### 2.2.3 AMENDMENT 12: CPH

#### PPC metal panels to plant rooms in lieu of glazing

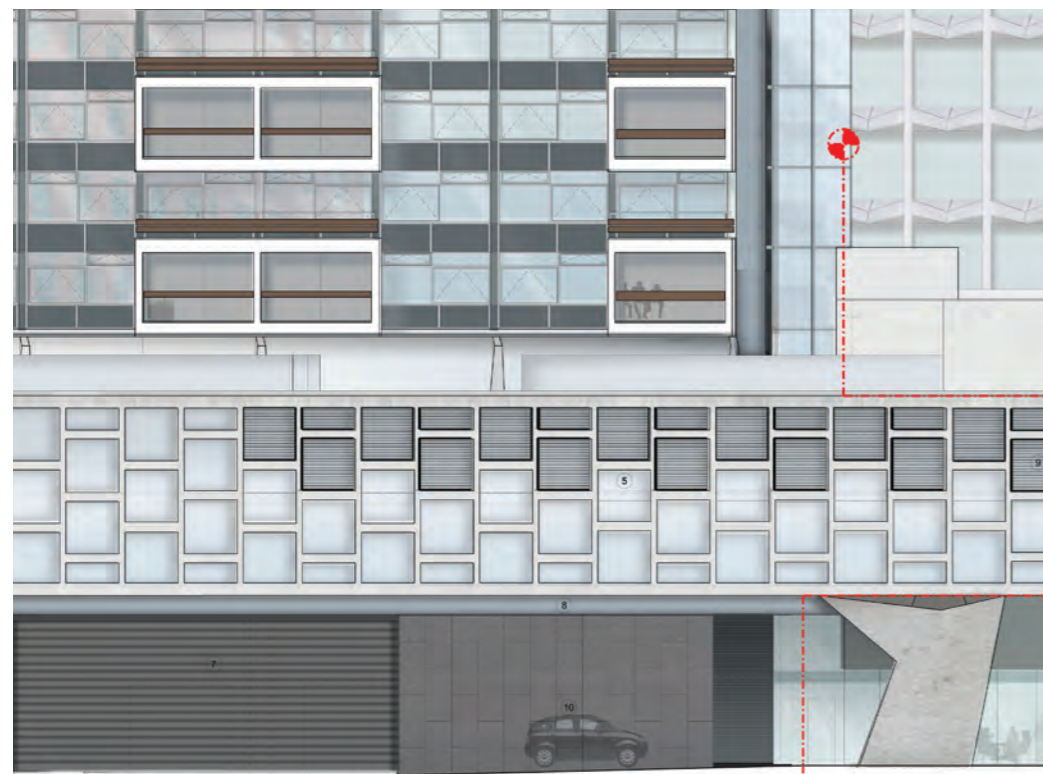
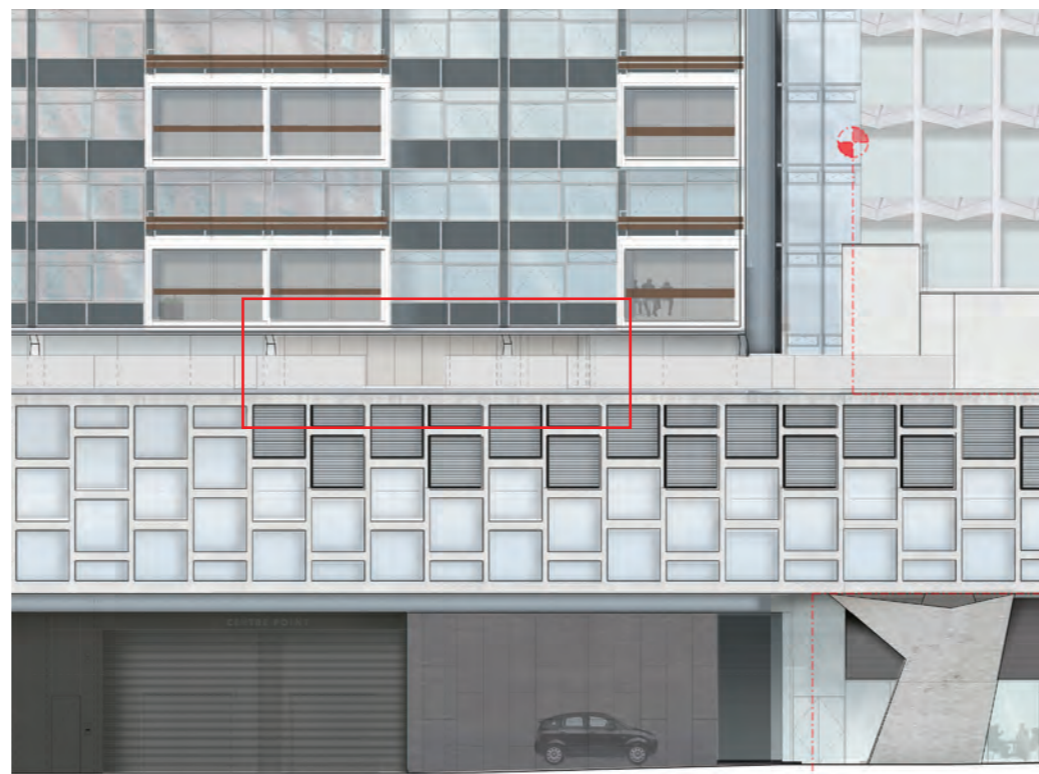
As the detailed design has developed it has become clear that achieving a robust, weathertight and acoustically satisfactory detail at the penetration of the ecology ducts and the clerestory glazed facade would be extremely difficult. This would run the risk of future maintenance issues and reduced acoustic performance. It is therefore proposed to minimise this by replacing the currently consented obscure glazing between gridlines U/6\*-8 & U/11-12 on the level 02 east facade with PPC metal panelling in order to better conceal the plant rooms behind and to allow satisfactory junctions to be formed which will achieve the necessary acoustic insulation requirements.
